Weber Dam and Reservoir are located on the Walker River within the Walker River Paiute Indian Reservation in west-central Nevada. The dam is located in Mineral County about 132 miles southeast of Carson City and 8 miles upstream from Schurz. It was constructed in 1934-1935. The reservoir contains approximately 10,700 acre-feet at the normal water surface elevation of 4208.0 feet. The reservoir also has an authorized surcharge capacity of about 2 feet and contains approximately 14,900 acre-feet at the surcharge water surface elevation of 4210.0 feet. The primary use for the reservoir is irrigation, and no other congressionally authorized uses are listed within the National Dam Directory. The drainage basin upstream from the dam is about 2,650 square miles and extends into the California Sierra Nevada Range.

Weber Dam Modification

VALUE ENGINEERING STUDY

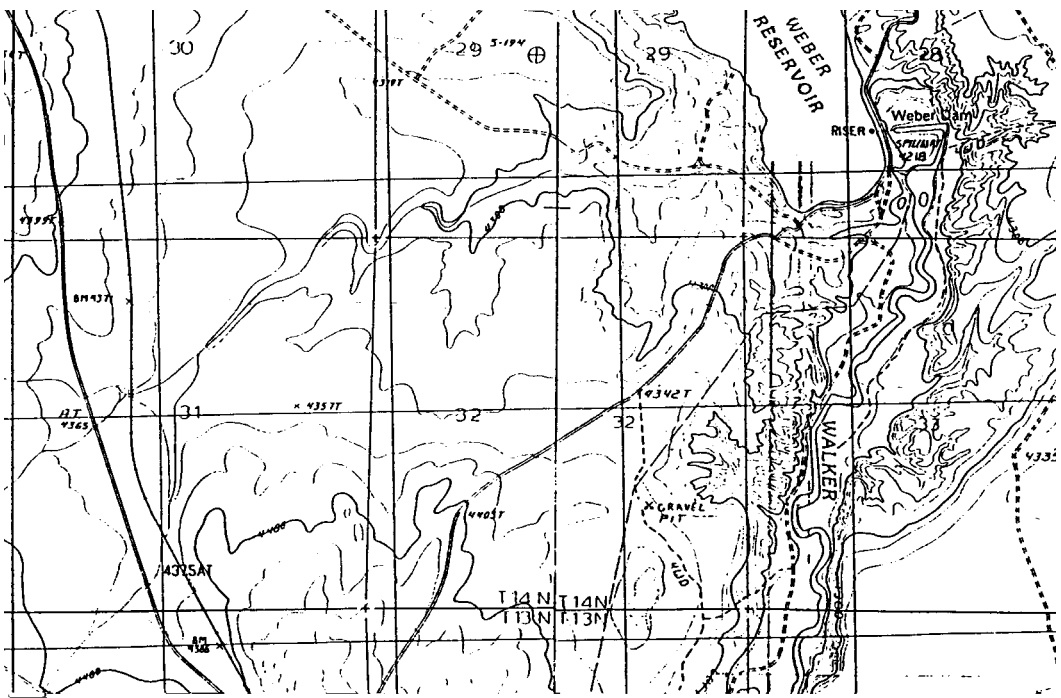
██████████ Weber Dam Modification
██████████ RELOCATE THE DAM EMBANKMENT UPSTREAM OF THE FAULT.
██████████ The concept design centers the dam embankment on the fault and adds a stability berm to the downstream slope to earthquake prevent failure. The outlet works conduit would be extended downstream.
██████████ The dam embankment would be located upstream of the fault and the outlet works conduit would be extended upstream through the dam.

██████████ Weber Dam Modification	
██████████ ██████████	██████████ Prevent MCE Failure
██	
The dam embankment would be located upstream of the fault and the outlet works conduit would be extended upstream through the dam.	
██████████	██████████████████
Reduce the volume of fill material, including filter material, partially due to the narrower crest.	Requires extension of the outlet works about 100 feet upstream of the existing inlet. The existing outlet works tunnel will have to be evaluated for bearing capacity to ensure it can withstand the new embankment.

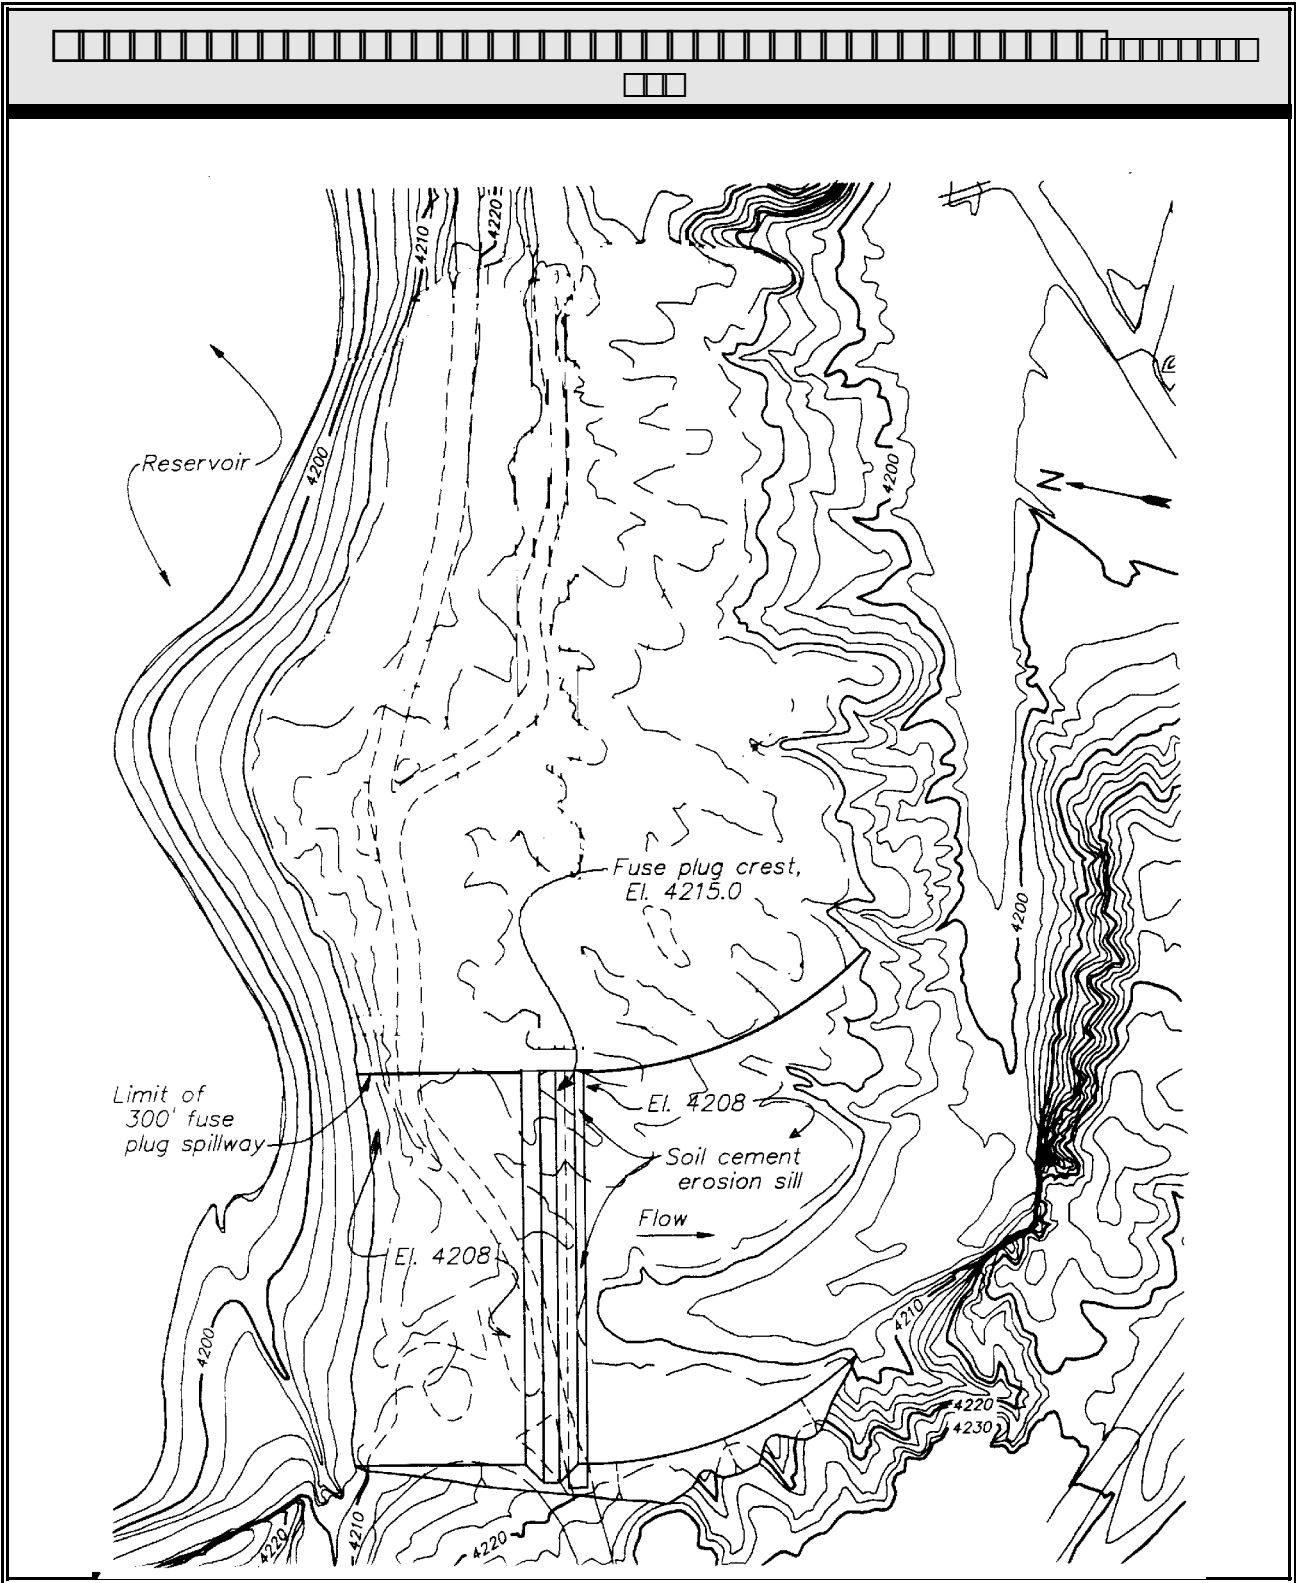
<input type="checkbox"/> Weber Dam Modification
<input type="checkbox"/> RELOCATE THE DAM EMBANKMENT DOWNSTREAM OF THE FAULT.
<input type="checkbox"/> The concept design centers the dam embankment on the fault and adds a stability berm to the downstream slope to earthquake prevent failure. The outlet works conduit would be extended downstream.
<input type="checkbox"/> The dam embankment would be located downstream of the fault and the outlet works and walkway would be rebuilt in its entirety and the conduit would be extended downstream through the dam. This proposal was estimated based on percentages of the quantities used in the original concept and its alignment.

<input type="checkbox"/> Weber Dam Modification	
<input type="checkbox"/>	<input type="checkbox"/> Prevent MCE Failure
<input type="checkbox"/>	
<p>The dam embankment would be located downstream of the fault and the outlet works would be rebuilt in its entirety or the conduit would be extended downstream through the dam.</p>	
<input type="checkbox"/>	<input type="checkbox"/>
<p>Moves the alignment entirely off the fault.</p> <p>Reduce the volume of fill material, including filter material, partially due to the narrower crest.</p> <p>Eliminate construction of the downstream berms at the left abutment and the outlet works.</p> <p>Out of the Q_e formation material.</p> <p>May eliminate the need to rehabilitate the outlet works tunnel.</p> <p>Outlet works tower could be relocated within the center section of the embankment, thus increasing its resistance to earthquake loading.</p>	<p>Requires additional exploration, ie. cone penetrometer tests.</p> <p>Destroys additional wetland that will have to be replaced as mitigation.</p> <p>Requires relocation of the outlet works tower. Can possibly use the existing outlet works tunnel. Will have to evaluate the bearing capacity of the tunnel to ensure it can withstand the new embankment.</p>
